BUILDINGS 5 & 6 RENOVATIONS

CAÑADA COLLEGE

FIRST FLOOR
INTERIOR ELEVATIONS

Date	08/29/08	Drawing Number	A8.1
Scale	AS NOTED	Project Number	07013

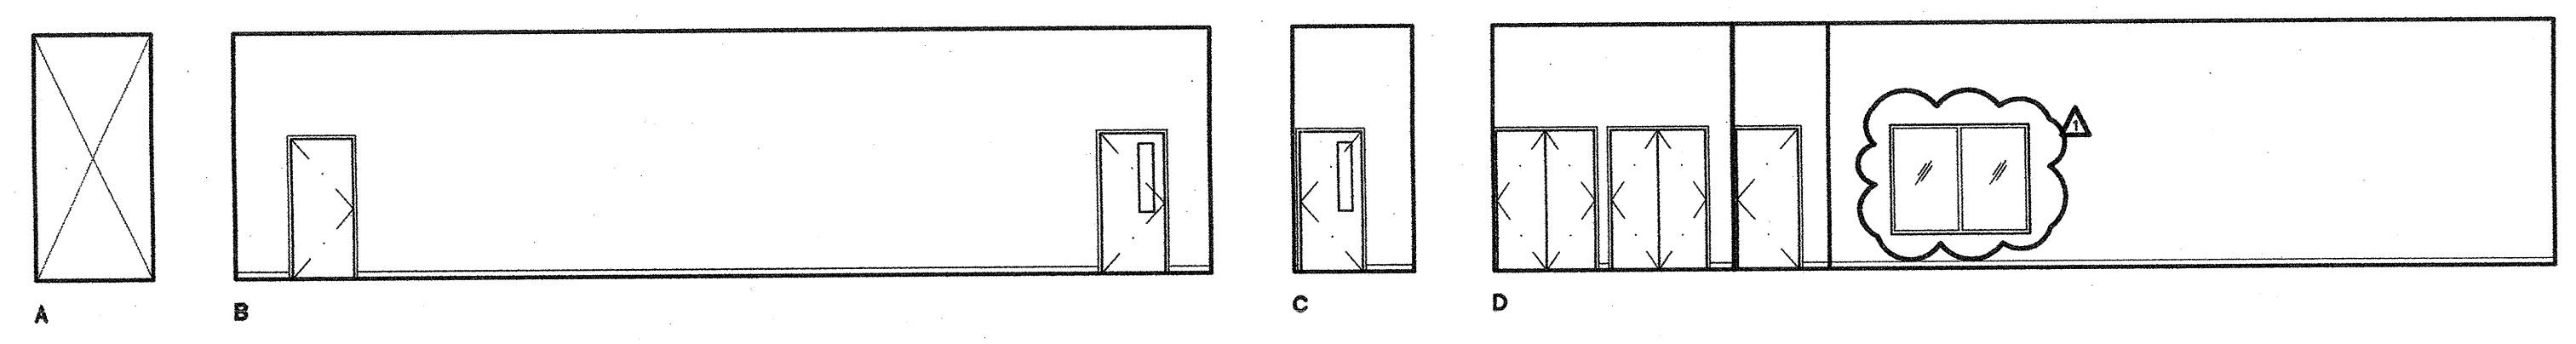
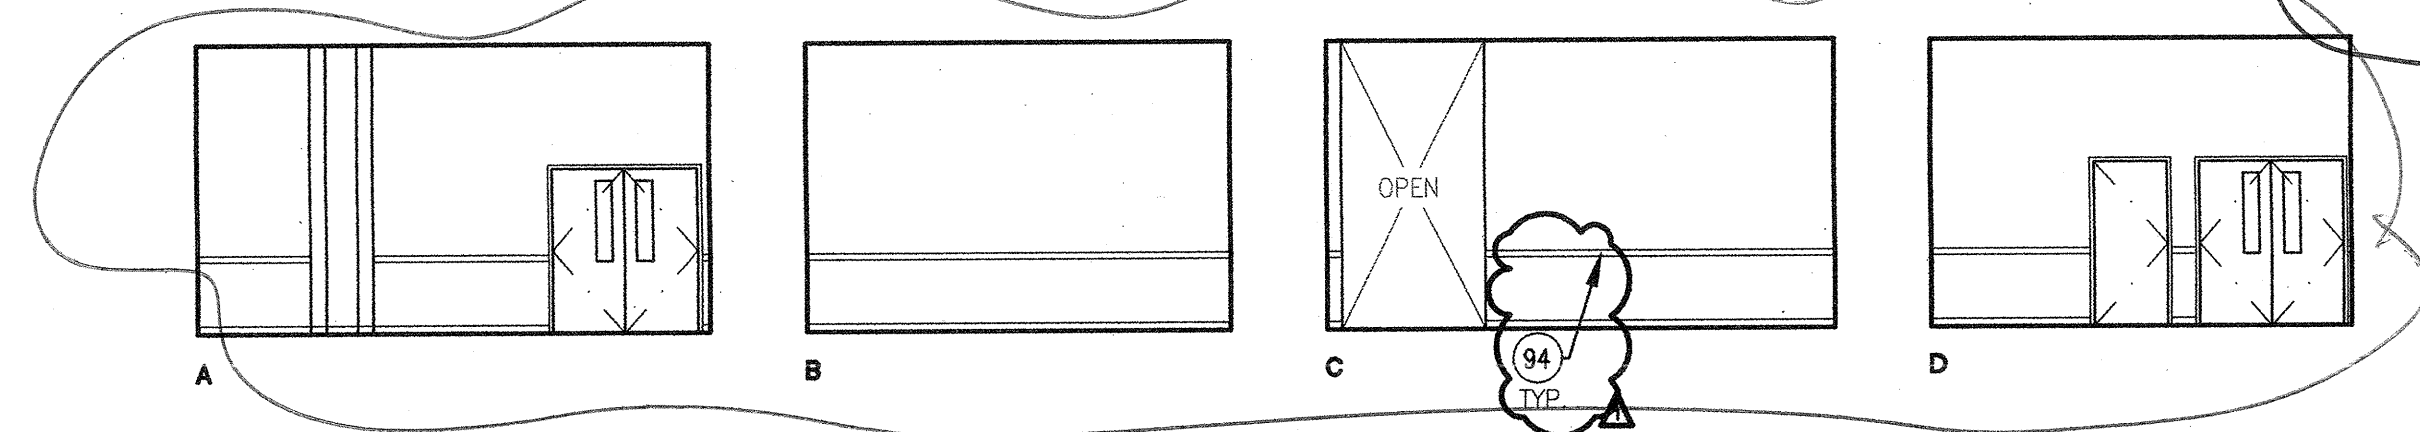
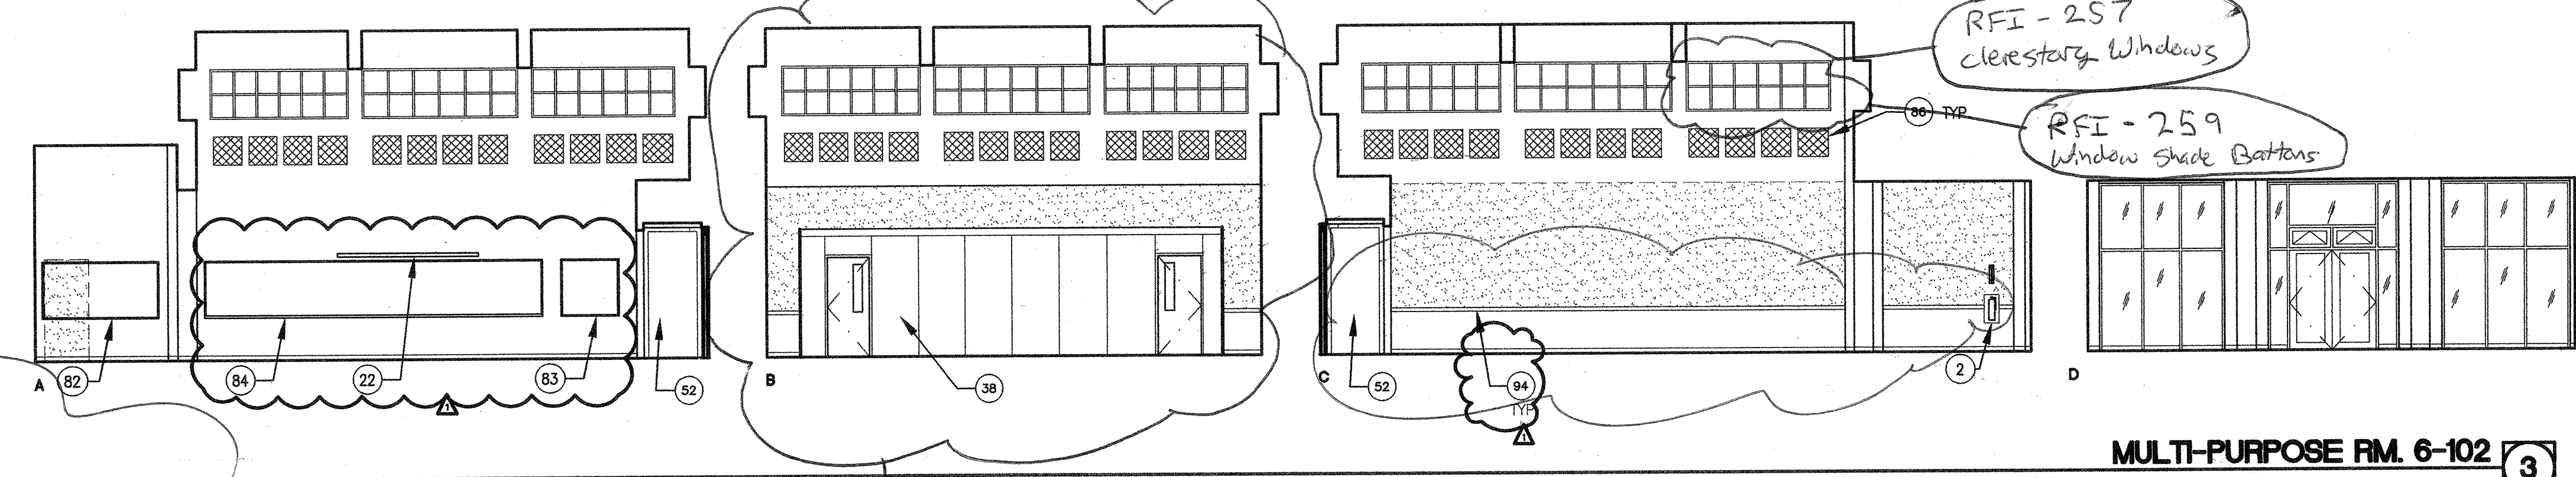
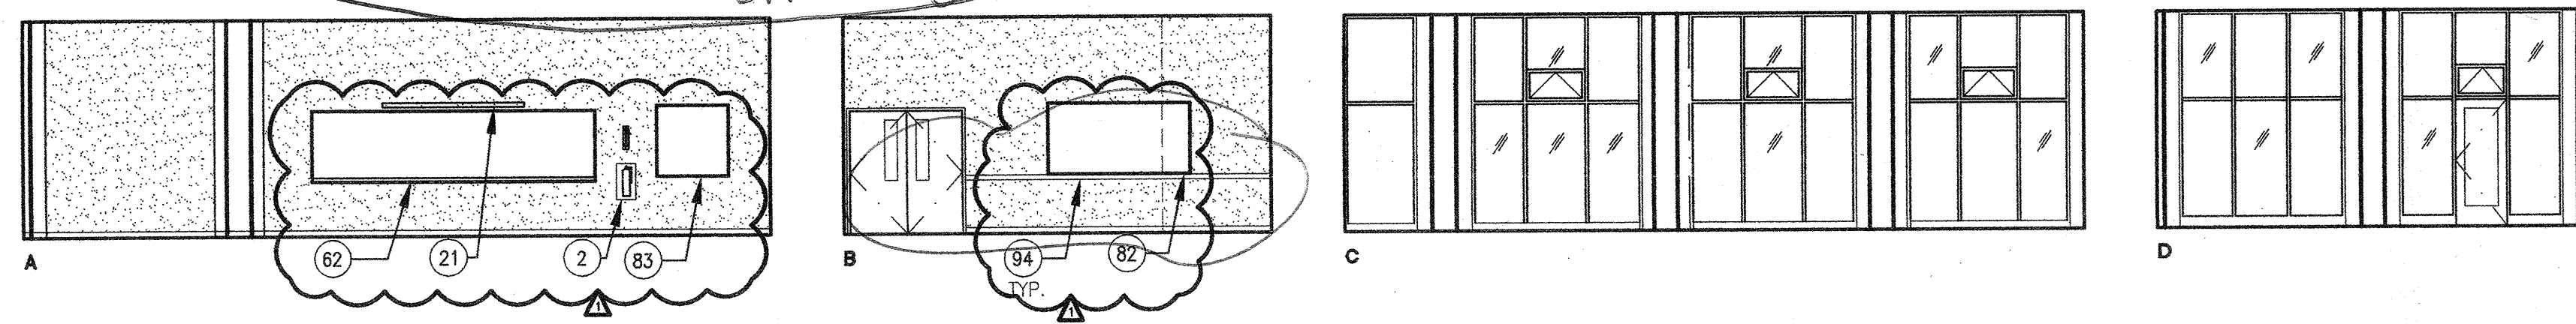
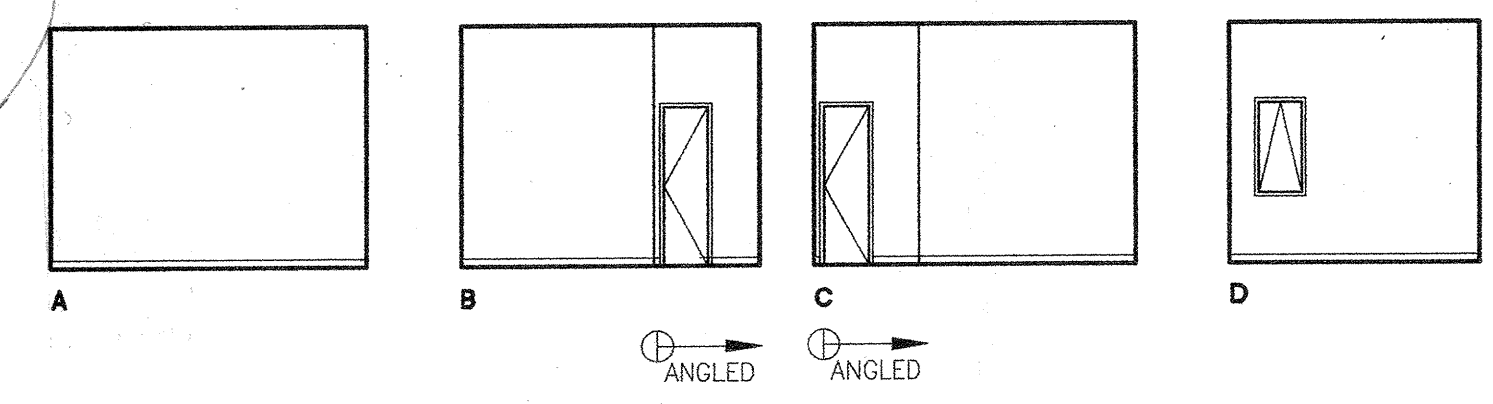
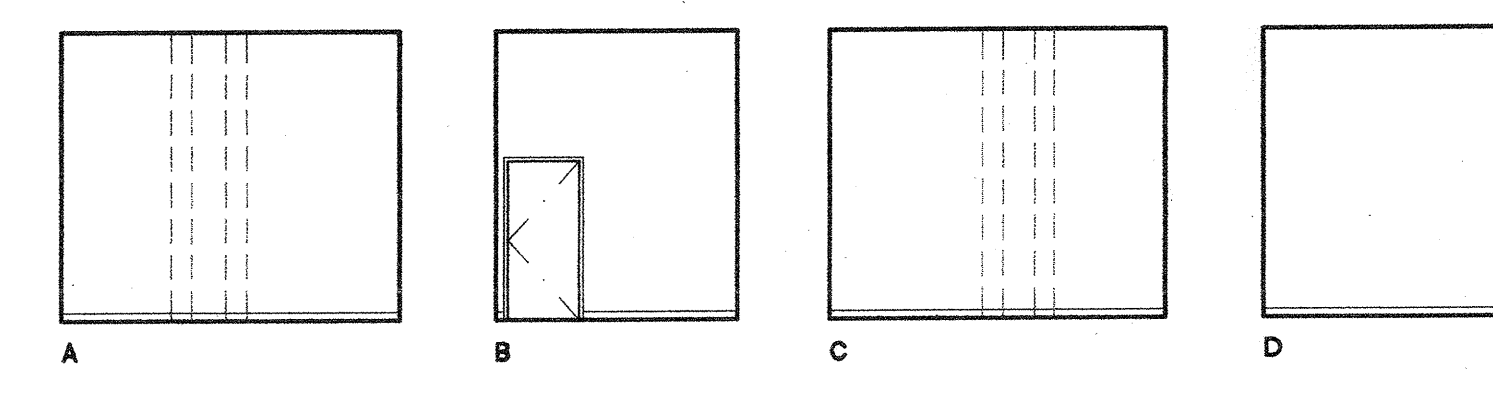
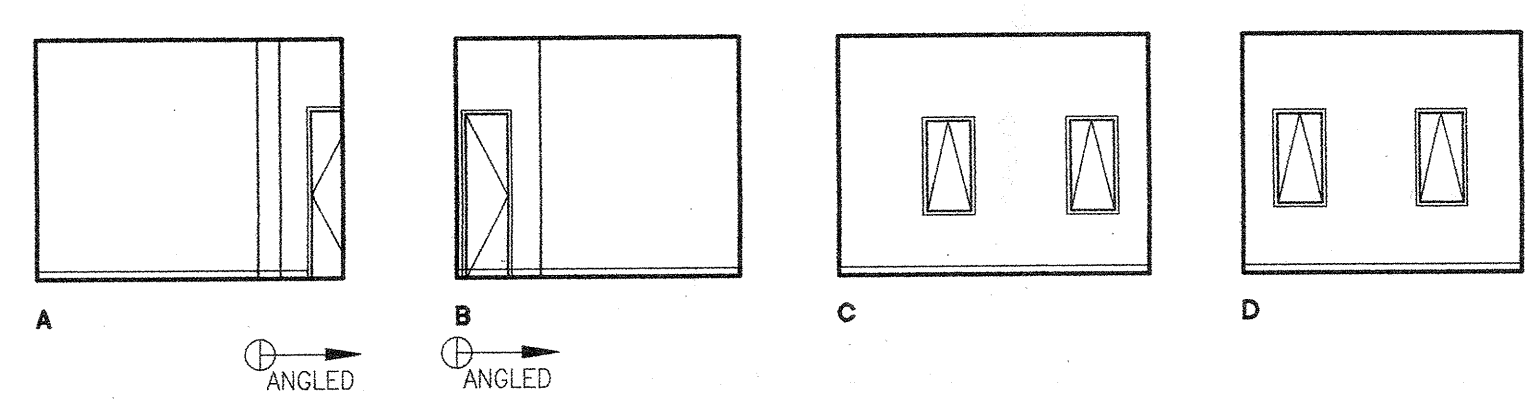
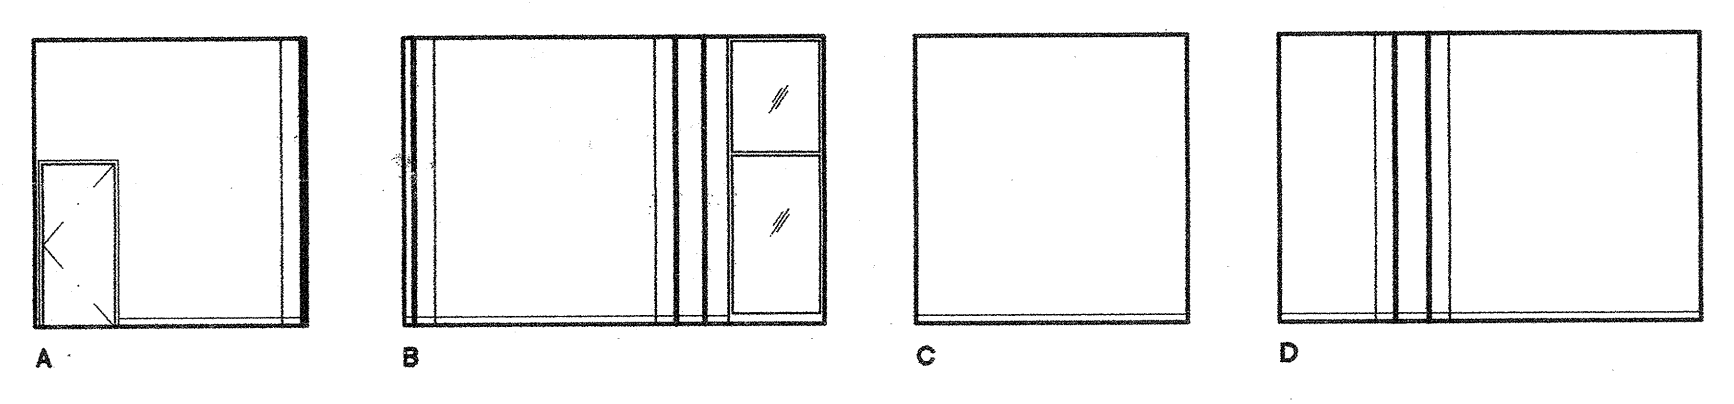
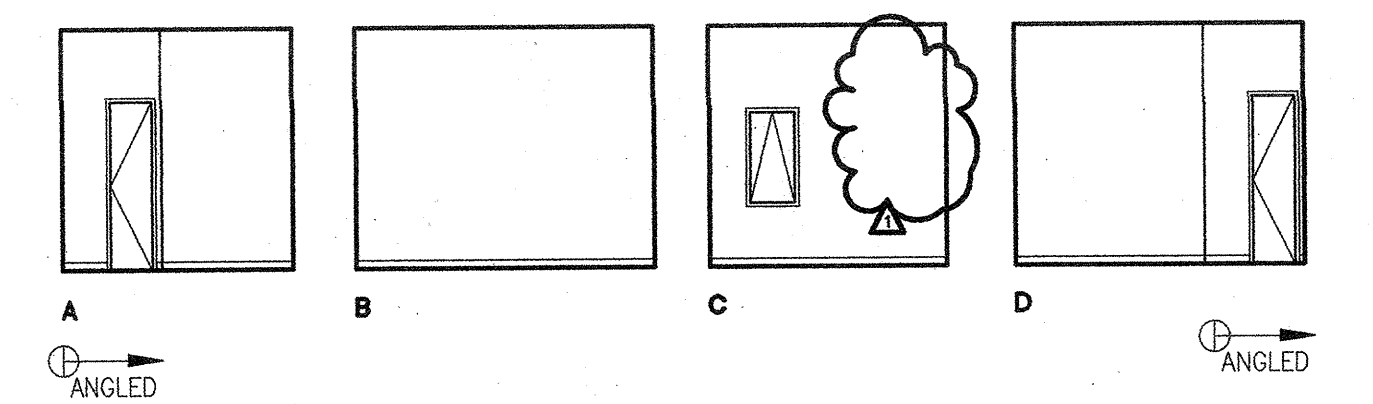
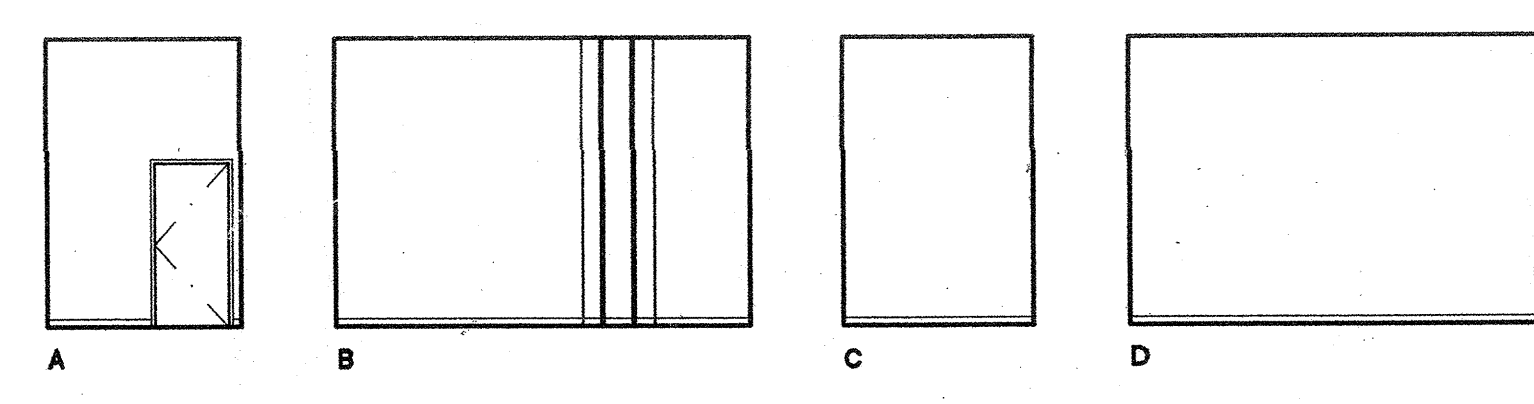
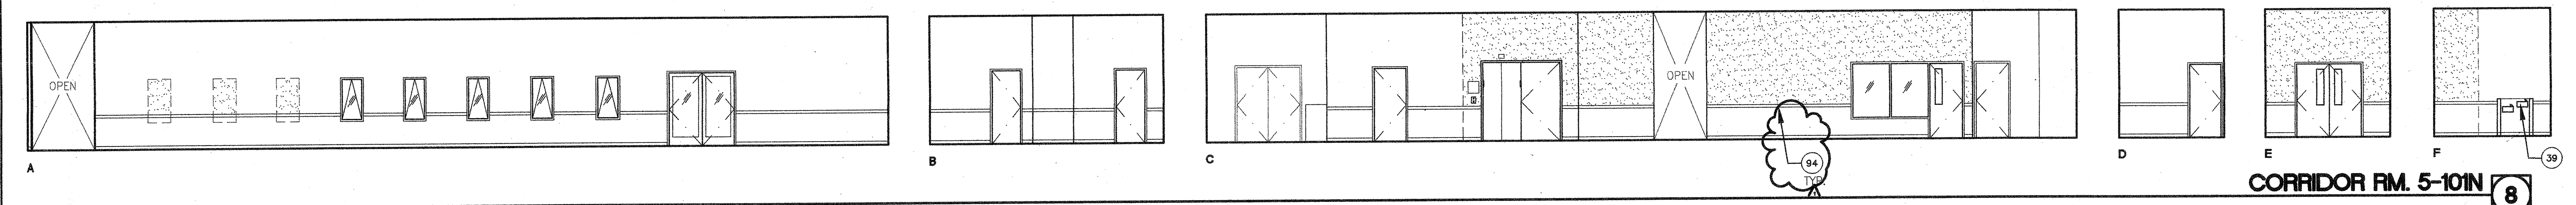
SEE ALEX ACENAS E-MAIL ATTACHMENT

Thanks for setting me up with Phil (and Scott) yesterday afternoon. I got to see a meeting room and a classroom in CSM B5. Based on what I saw, I think the top of the chair rail should be at +36" AFF, +/- 0.5". This will allow the bottoms of tack boards, white boards and marker trays to be at +36" AFF, and also allow the chair rail to run continuously below existing window openings in the exterior concrete wall. Although table edges and chair backs are around 29"-30" AFF, the walls would still be protected by the vinyl wainscot below the chair rail.
